REQUEST FOR PROPOSALS – **ADDENDUM #1: FAQs**  
CITY OF GILLETT –  
ZIPPEL PARK IMPROVEMENTS PROJECT  
OCONTO COUNTY, WISCONSIN

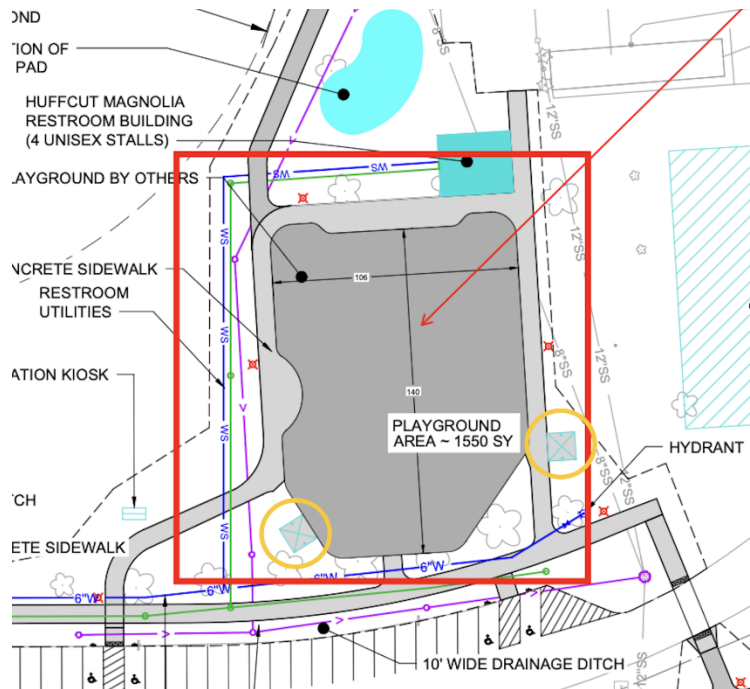
**Q9:** In the graphic below, could you please clarify what is intended for the areas circled in yellow? Are these designated locations for open shelters? If so, would you like us to include the shelters and/or associated seating in our playground proposal?

**A:** The yellow circles will be shade areas with benches or picnic tables. We are having them donated to us and not part of the playground RFP.
